Royal Canal Urban Greenway

Non-Statutory Public Consultation Report

Fingal County Council

July 2022

Figure 5.1 Photograph of existing southern embankment (left) Vs Photomontage of cantilevered boardwalk (right), facing west towards Kirkpatrick Bridge

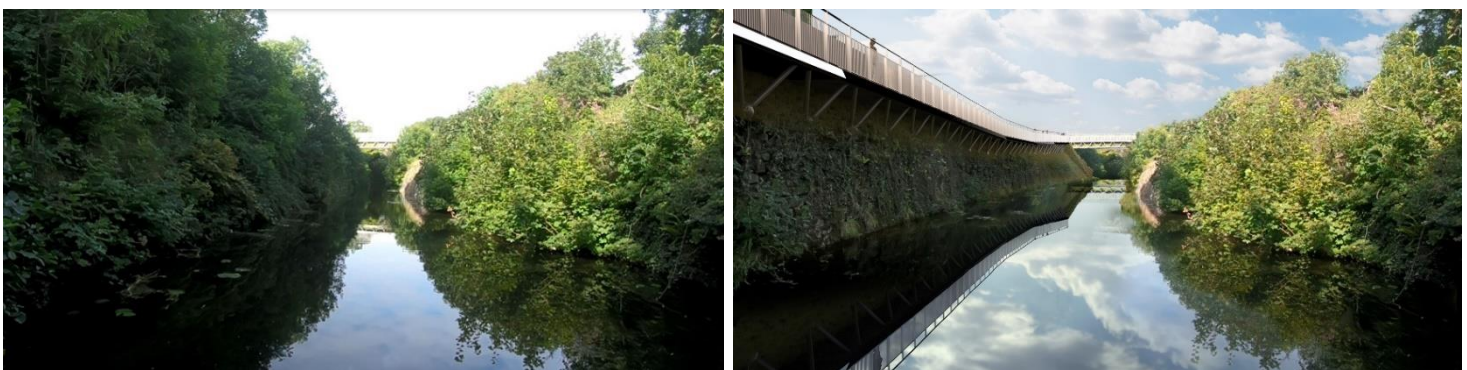
- f) The southern option would require the removal of the majority of vegetation along the southern corridor which would have a significant environmental and visual impact.

- g) The required cantilevered boardwalk would result in a significant visual impact on the Deep Sinking Area.
- h) The cantilevered boardwalk would result in a significant impact on the heritage of the Deep Sinking Area completely changing its character. It would also result in the shading of a significant portion of the canal at this location.

Figure 5.4 Cross section of greenway behind Delwood Park (Source: Architectural Drawings – Appendix B, Public Consultation Document)

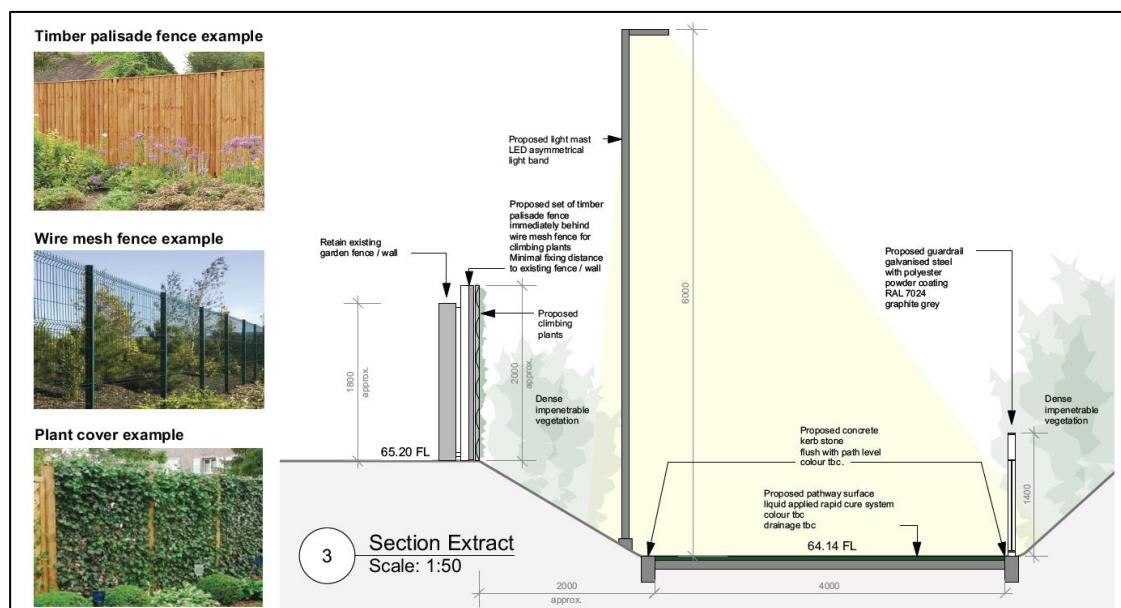
- 5.5.2 A number of submissions requested further information on the height and cover materials for proposed fencing at the back the Delwood Park properties. To prevent the greenway overlooking the back gardens of the residents of Delwood Park and for security reasons, the ground level of the greenway is now proposed to be lowered to match, or be lower than, the existing ground level of the adjacent back gardens and a 2m high timber palisade fence provided, with an anti-climb wire mesh or similar type fence. Defensive planting will also be provided here to increase security and minimise visual intrusion.

- 5.5.3 See Figure 5.4 below of the proposed security fence (source: Royal Canal Urban Greenway, Public Consultation Document, Appendix B – Architectural Drawings. <https://consult.fingal.ie/en/consultation/royal-canal-urban-greenway>).

Figure 5.5 Comparison between the bridge location/access ramp for both Public Consultation periods 2019 & 2020.

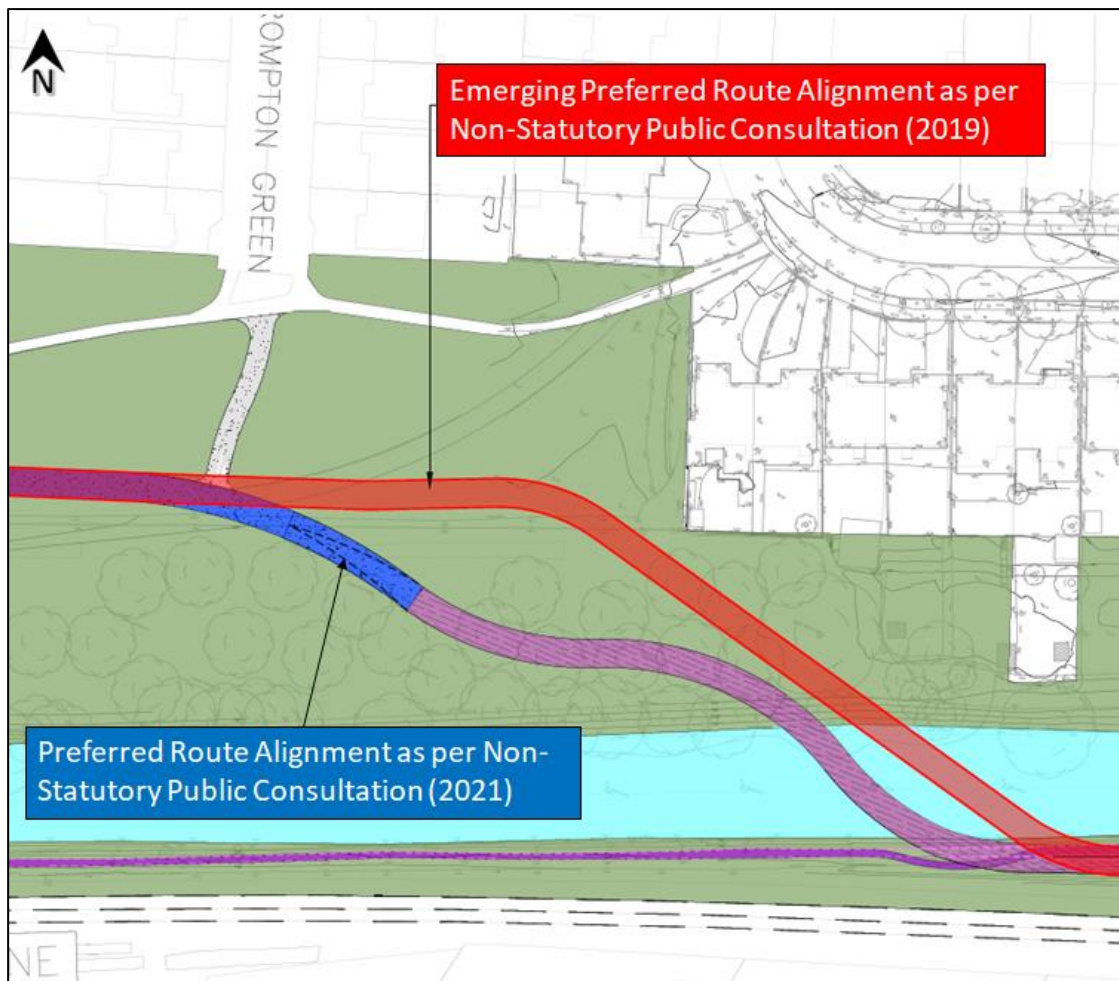
- 5.5.8 Another common concern was regarding the height of the bridge crossing the canal and the potential impact on privacy for residents. Following concerns raised in the first Non-Statutory Public Consultation regarding the proximity of the proposed bridge with Roselawn properties, the bridge access route/ramp from the Brompton Green area has been shifted further west, with the bridge route/ramp meandering through the wooded area, which should act to screen the bridge access ramp from the Roselawn properties, see Figure 5.5 below.

- 5.5.9 Following consultation with Waterways Ireland (WI), 3.5 - 4m height clearance is required above the canal at bridge crossing location to allow barges to pass under.
- 5.5.10 The towpath must also be maintained to enable the towing of barges and for maintenance purposes. A 3m height clearance is required along the towpath under the bridge sections for maintenance machinery.

Response: Following concerns raised in the first Non-Statutory Public Consultation regarding the proximity of the proposed bridge with Roselawn properties and the potential visual impact, the bridge access route/ramp from the Brompton Green area has been shifted further west, with the bridge route/ramp meandering through the wooded area, which should act to screen the bridge access ramp from the Roselawn properties, see Figure 5.5.

Figure 5.7 Comparison between the greenway entry point into the Brompton green area for both Public Consultation periods 2019 & 2021.

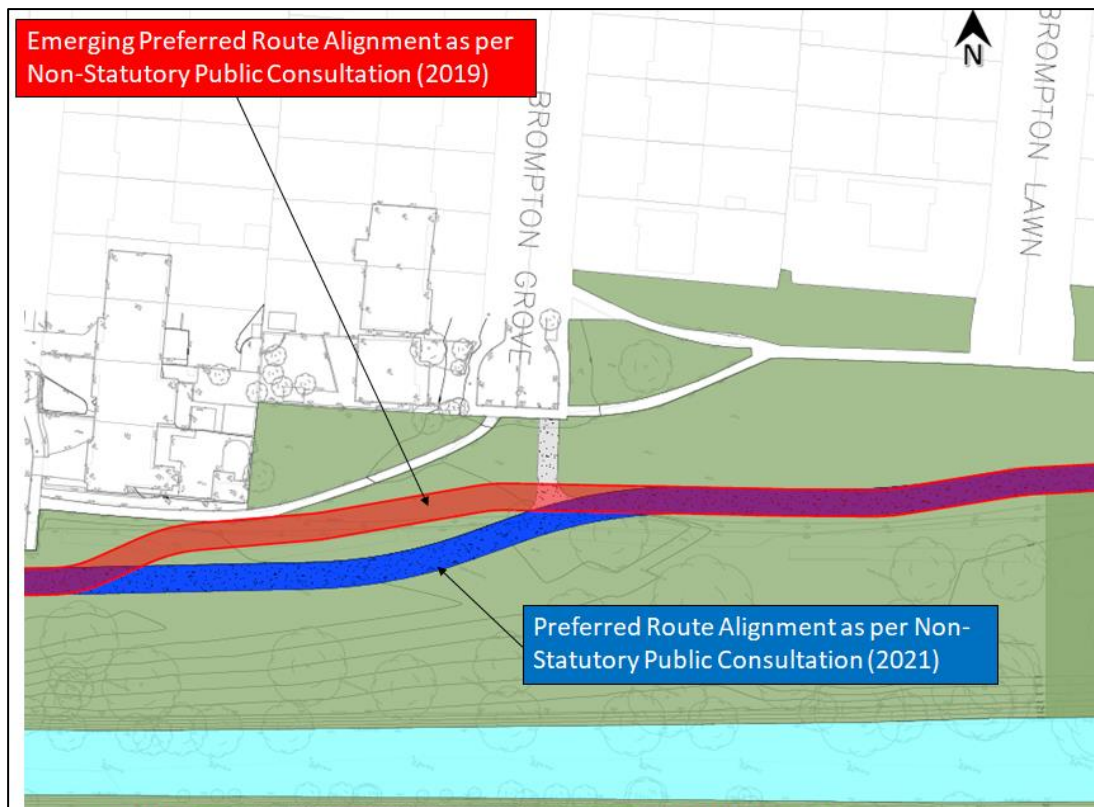
- 5.5.13 In the 2019 Non-Statutory Public Consultation, there were concerns about opening the existing fence line on the southern side of the Brompton green area and the potential issue of anti-social behaviour in the wooded area that previously occurred. Accordingly, the design now includes a 2m high fence line to be maintained along the southern side of the greenway along this section of the greenway route. To provide further privacy to the Brompton residents, planting and railings will be provided on the Brompton side of the greenway through the Brompton green area, see image below from the Public Consultation Report and 3D Animation video (Figure 5.8).

- 5.5.11 The proposed pedestrian and cycle bridge tie-in on the southern towpath has been chosen east of the pinch point created by the railway masonry retaining wall and the towpath at Ch. 7000-7160. The towpath begins to widen from Ch.7220 eastwards towards Granard Bridge, which provides sufficient available width for the bridge abutment and greenway, while maintaining at least 4.5m (minimum) separation from Iarnród Éireann assets. The proposed bridge has been architecturally designed to be aesthetically pleasing and fit into surrounding environment.
- 5.5.12 To respect the privacy of adjacent properties, the access point into the Brompton green area has been shifted eastwards from the previous consultation drawings (2019), see Figure 5.7 below.

Figure 5.10 Access points to the greenway proposed in the Preferred Route Option (Non-Statutory Public Consultation 2021).

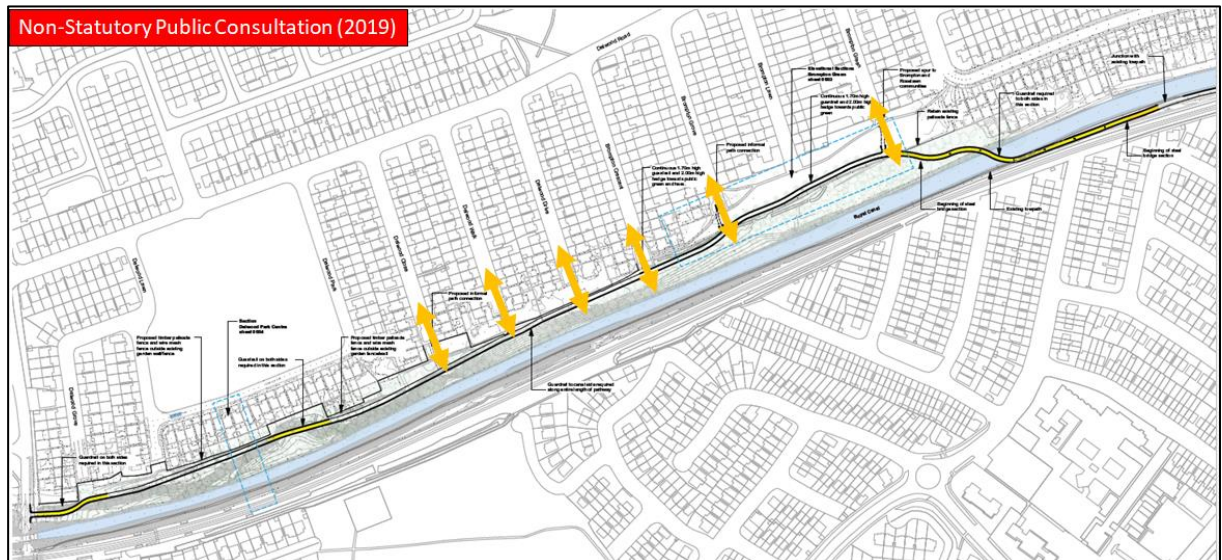
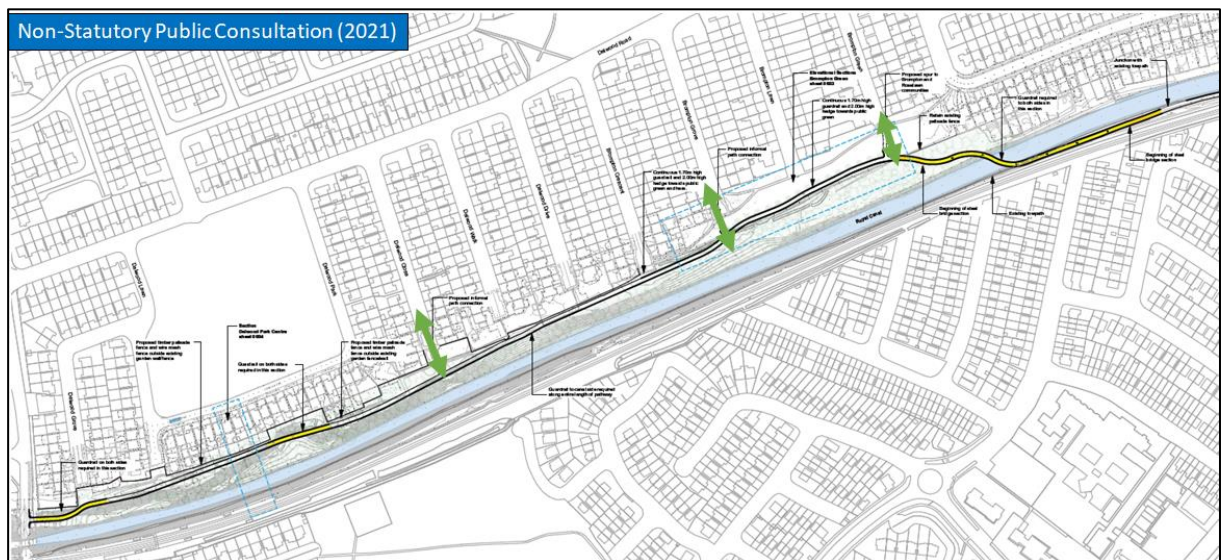
5.6.2 A number of submissions received expressed concerns regarding the potential impacts on Delwood and Brompton residential estates by providing access points onto the greenway from Delwood Close and the open space at Brompton. Concerns raised in relation to the proposals included anti-social behaviour, crime, traffic and parking.

5.6.1 Following concerns raised by residents in the previous non-statutory consultation in 2019, the number of accesses to the greenway via Delwood and Brompton has been reduced, see Figures 5.9 & 5.10.
